**GOVERNMENT OF THE DISTRICT OF COLUMBIA
DEPARTMENT OF TRANSPORTATION**

MEMORANDUM

SUBJECT: ZC Case No. 14-18A – Brookland Manor, Block 7

Figure 2. Stage 1 Block and Program Summary (Source: Applicant)

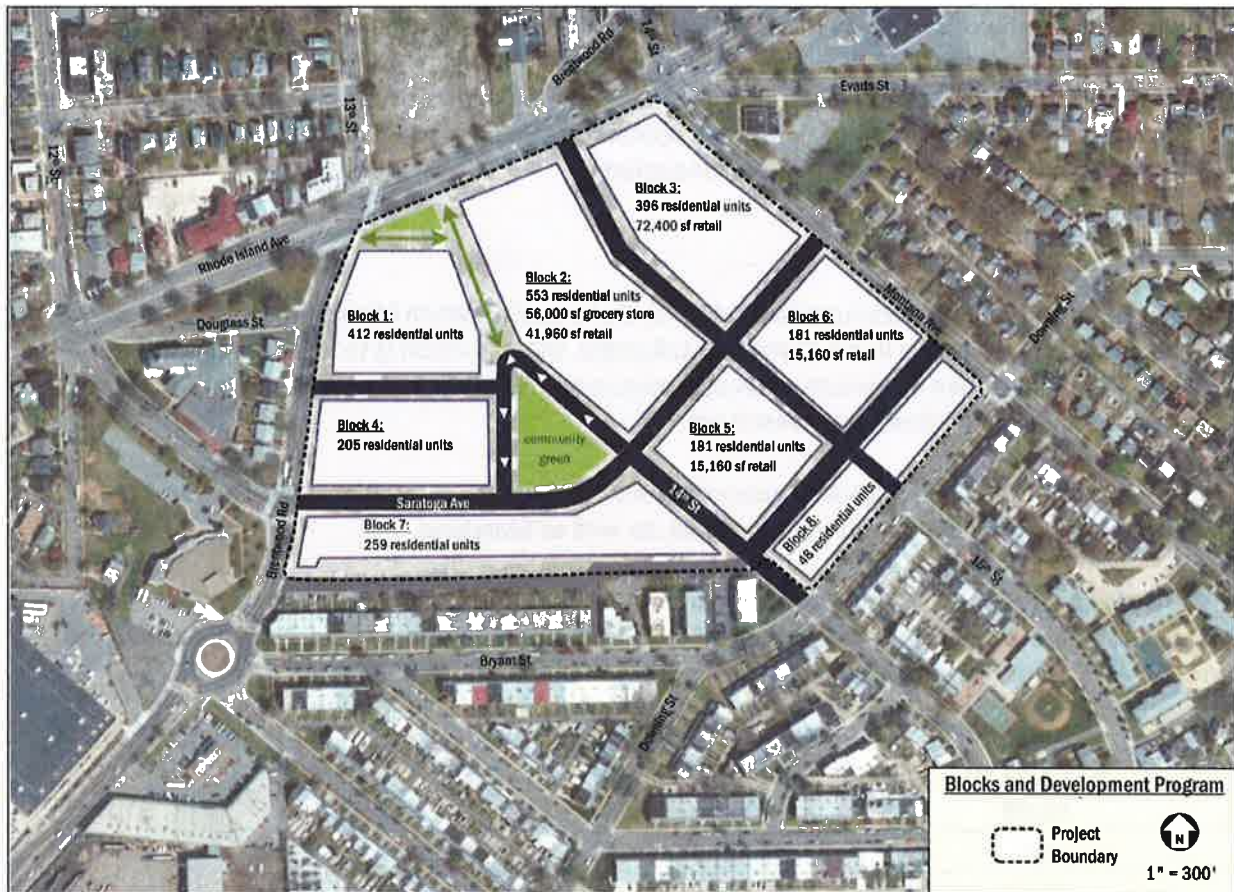
The block and program summary provided in Stage 1 is shown in Figure 2. At this time, only minor details on Block 7 are changed.

Figure 4. Pedestrian Pathways (Source: Applicant)

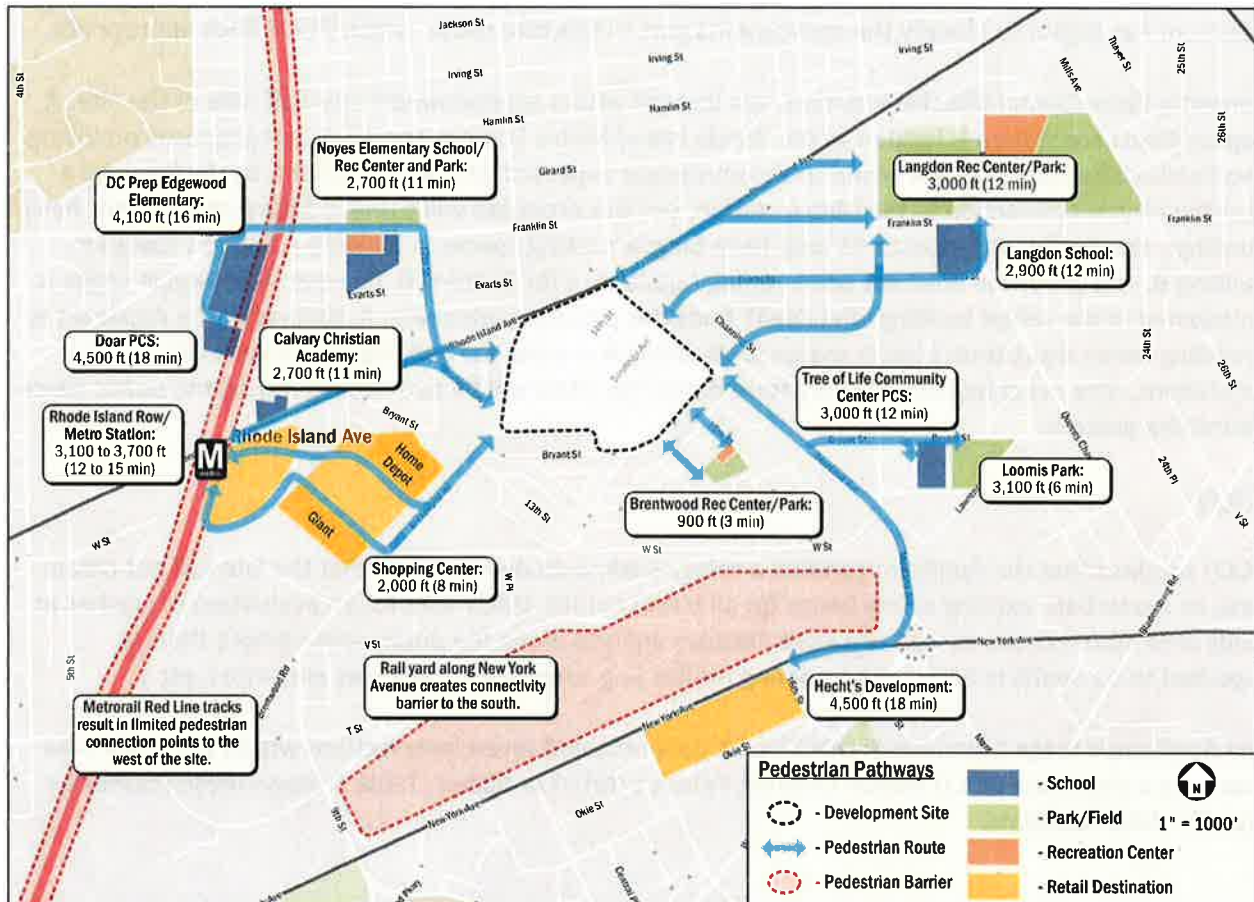
As discussed in the Site Access section, the Applicant is expected to work with DDOT through the public space permitting process and/or street dedication process to ensure that pedestrian access points provide safe and convenient Site access, with a focus on connecting to adjacent neighborhoods and connections to major trip production or attraction areas such as the Metro station. DDOT expects the Applicant to meet all DDOT standards for pedestrian facilities.

In this area, the key destinations are the Metrorail station as well as the local elementary school. DDOT expects the Applicant improve the pedestrian infrastructure along these routes to DDOT standards during the upcoming Stage 2 processes. For this phase, the Applicant has committed to improving the sidewalk along Saratoga adjacent to their Site, which DDOT finds appropriate.

Saratoga Avenue Right-of-Way Comparison

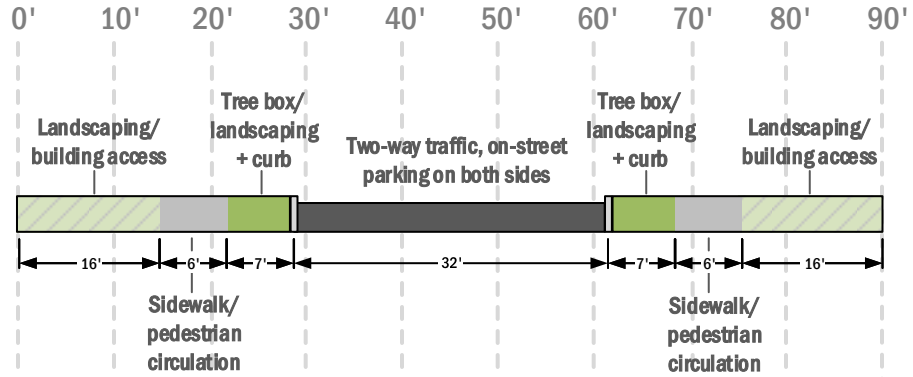
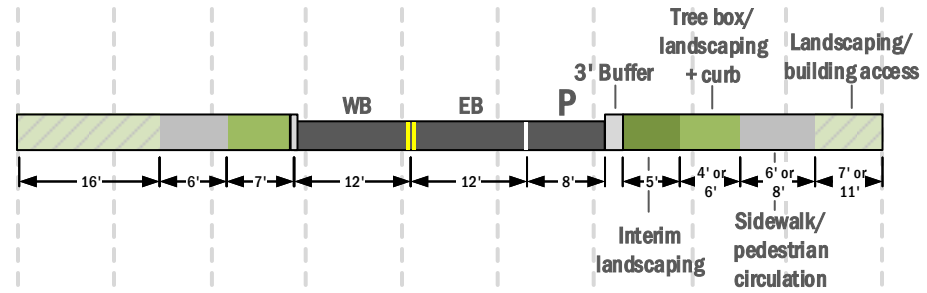
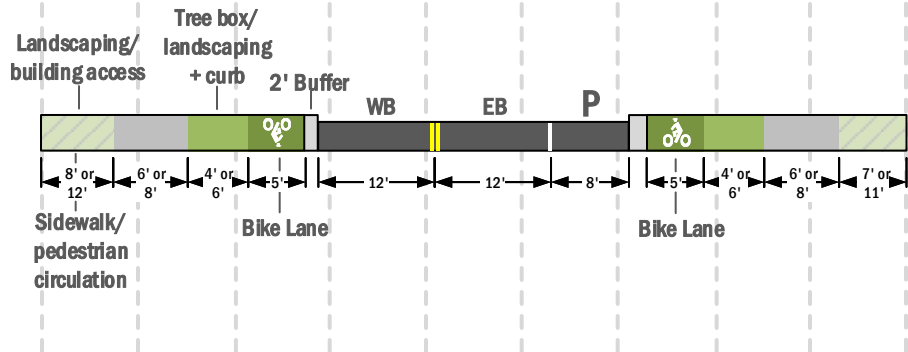
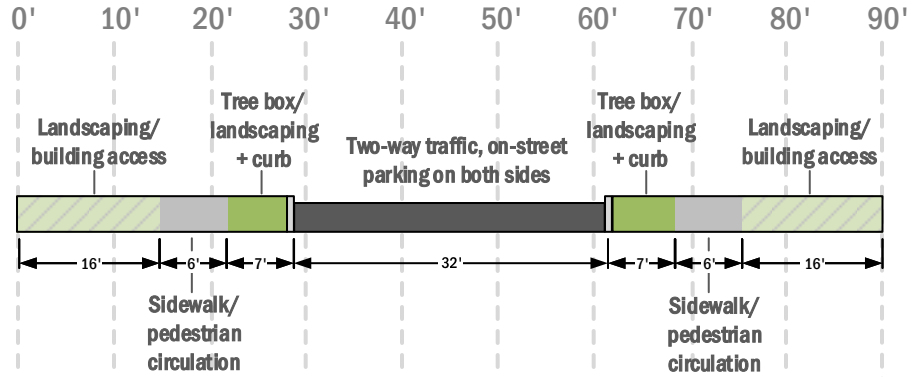
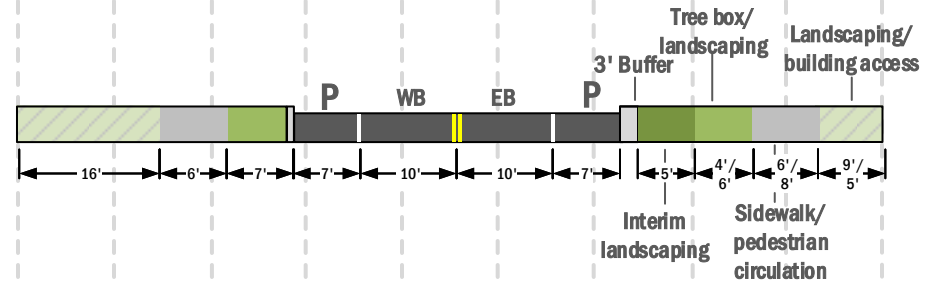
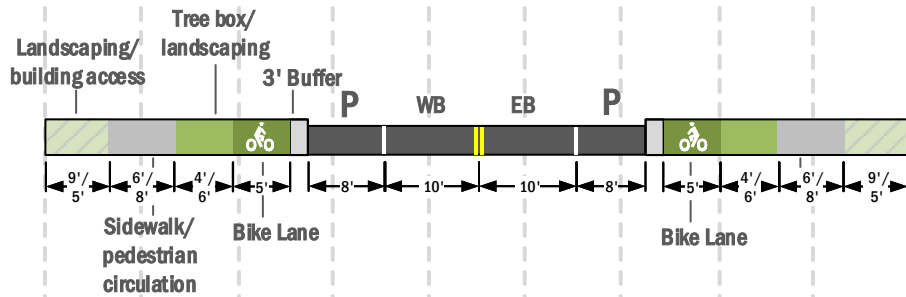
- The proposed street and public space layout concepts for the Site as shown in the February 10, 2017 CTR submittal are consistent with DDOT standards and provide the multimodal accessibility sought in Stage 1 dialogue. For Saratoga Avenue, two options for street layout are presented—Option 1 provides parking on only one side of Saratoga while Option 2 provides it on both sides. DDOT will seek Option 2; and

Two options are presented for Saratoga, which include interim improvements before final conditions are ultimately implemented as part of future project phases. These options show improved streetscape design as well as bike accommodations, which DDOT desired to support the proposed new bike route through the Site. Both options could make sense and meet minimum DDOT standards. DDOT will seek Option 2, however, which maintains parking lanes on both sides of the street.

The provision of on-street parking on streets adjacent to Block 7 is not expected to change, except for on Saratoga Avenue, which could have one parking lane removed in the first option presented. DDOT will seek to see both parking lanes remain.
